**INVER GROVE HEIGHTS
PLANNING COMMISSION AGENDA**

3.01 JAMES CUNNINGHAM – CASE NO. 15-02V

Case No. 15-02V

RE: Variance Request for Cunningham Parcel, Dalton Court; Case #15-02V

GRADING & EROSION CONTROL PLAN

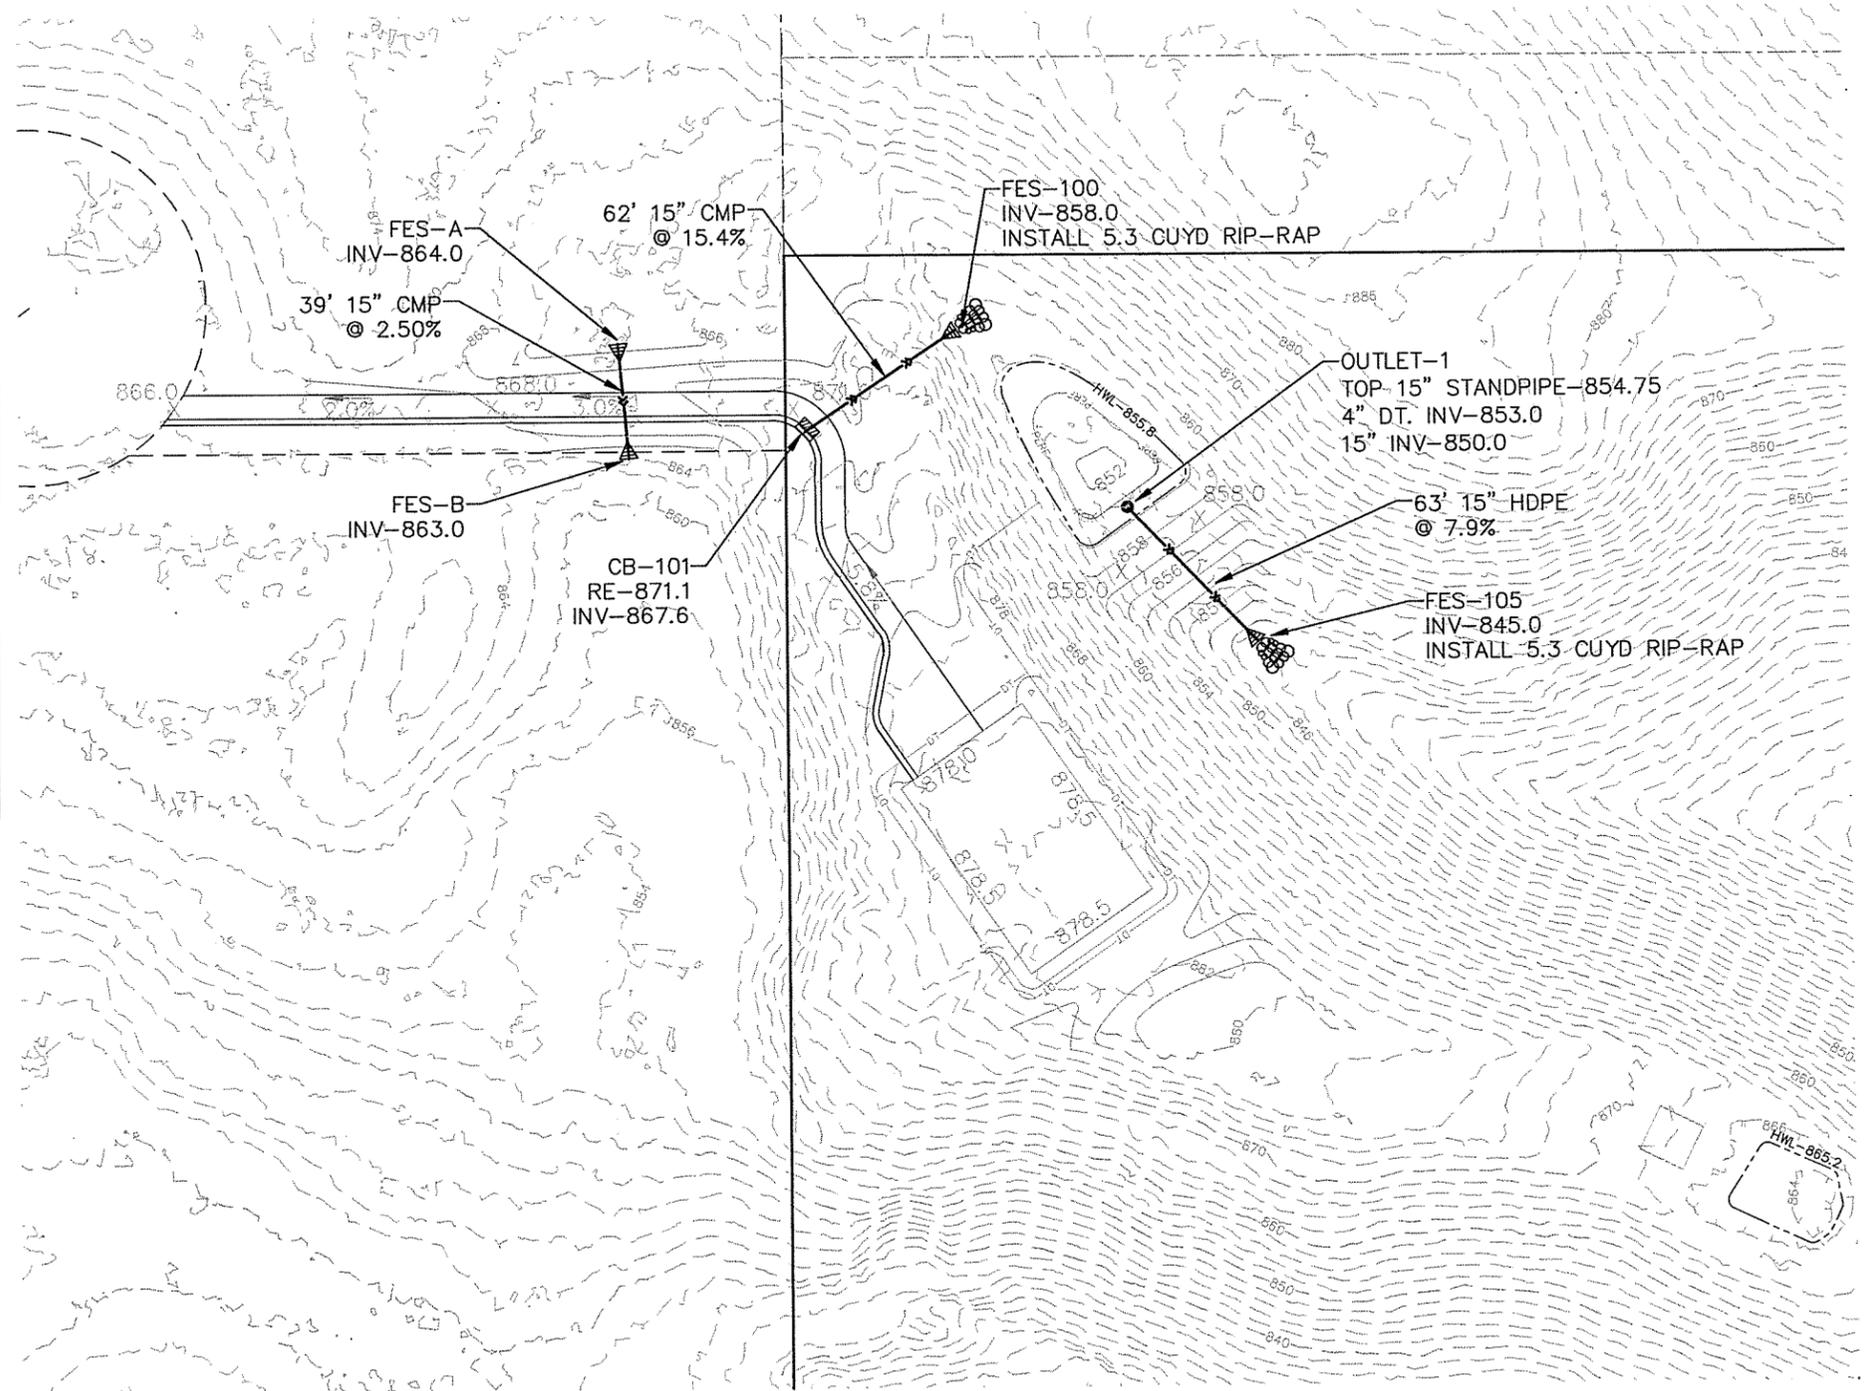
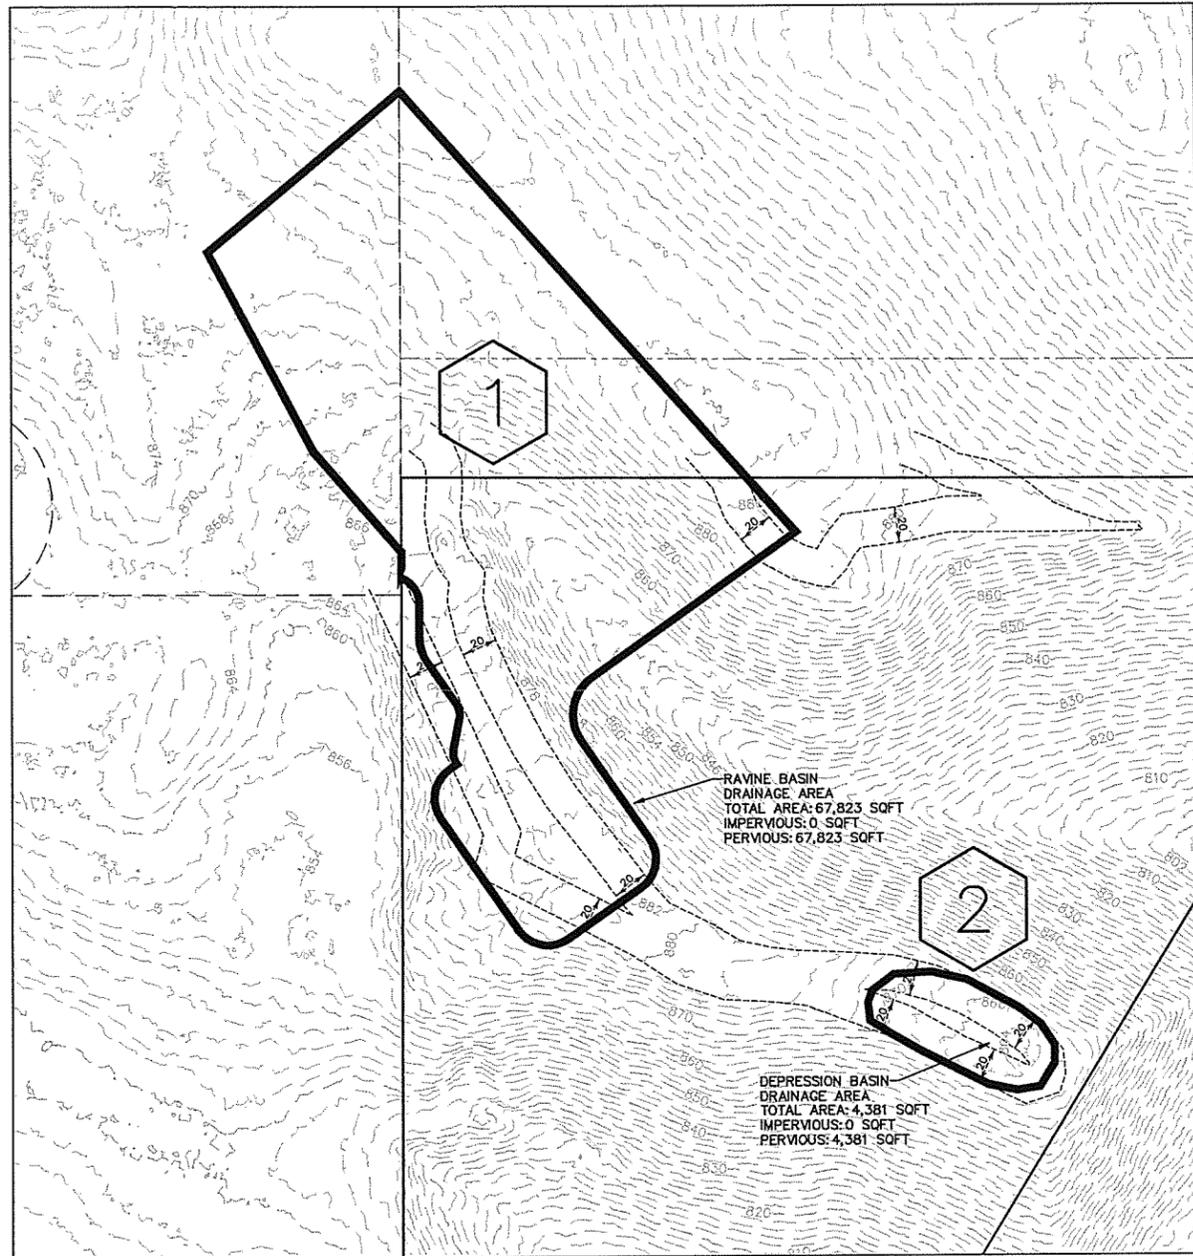
- The proposed plan shows a building pad of 50 ft X 76 ft with minimal grading into the slopes. The pad is shown at a zero setback from the top of bluff whereas a 40 foot setback is required.

- There would be some grading on slopes greater than 18% for the storm water maintenance system.
- Preliminary design of a septic system has been provided to show where a system could go. Any variance approvals and building permits would be subject to approval of the septic system design by the building inspections department.

Critical Area requirements are in place to minimize the impacts of development on steep slopes, bluffs, aesthetics and erosion. The property has a very narrow top of bluff that has the potential for being developed without much disturbance to the slopes or existing vegetation on the site. The building pad area shown, however, extends to the edges of the bluff line and there would be virtually no setback from the bluff. In Staff's opinion, in order to meet the spirit and intent of the ordinance, there should be some setback from the bluff. Since we are dealing with a building pad and not an actual building footprint, Staff recommends a building pad of no larger than 35 ft X 60 ft be allowed. This would provide at least a 10 foot setback from the bluff line. Without some required

The buildable area is small and should be limited to a reasonable size home. Staff does not support a variance for a gazebo shown at the far east end of the site. This is not needed to be allowed reasonable use of the property.

2. The approved building pad shall not exceed 35 ft X 60 ft and shall maintain at least a 10 foot setback from the bluff line.
3. A variance is not approved for a gazebo that shown on the site plan.

EXISTING CATCHMENTS

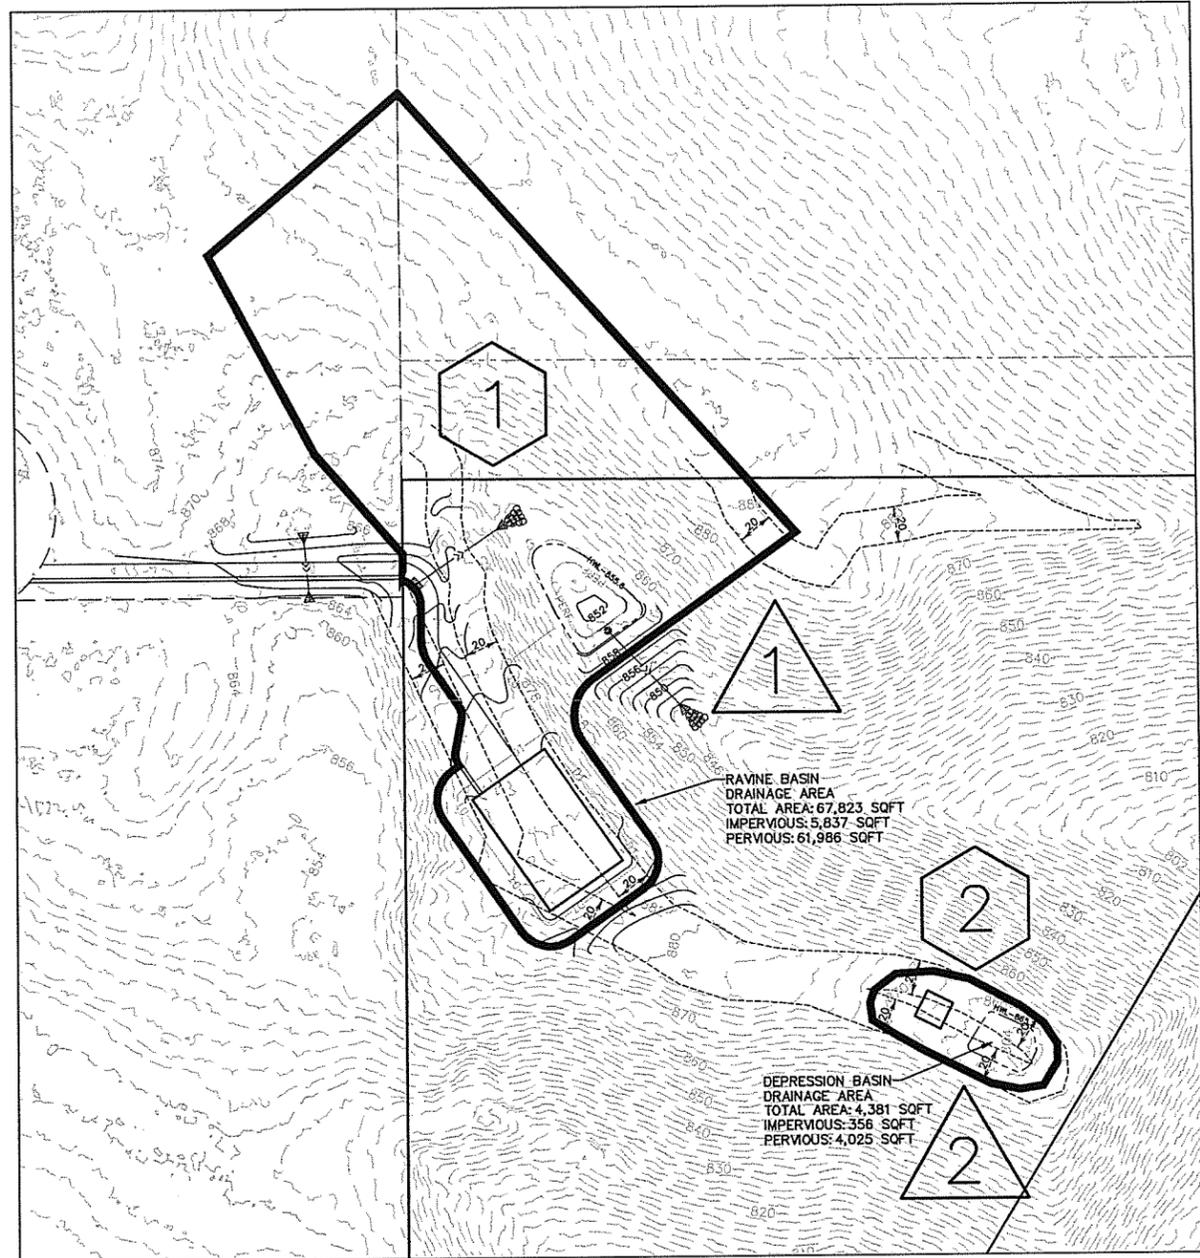
2. A Stormwater Facilities Maintenance Agreement (SWFMA) is required for all stormwater features on the site.
3. A stormwater management plan is required for the site to contain back to back 100 year Atlas 14 rainfall events and to prevent additional runoff down the bluff.

4. The outfall pipe shall include an anti-seepage collar.
5. The driveway drainage shall be directed to Dalton Court and/or the proposed stormwater feature.

6. The roof drainage shall be directed towards the proposed stormwater feature using gutters and downspouts.
7. The gazebo shall be constructed and graded to drain to the natural depression at the point of the bluff.

8. The natural depression at the point of the bluff shall be expanded to hold the back to back 100 year Atlas 14 rainfall events.
9. The access driveway shall drain toward Dalton Court.
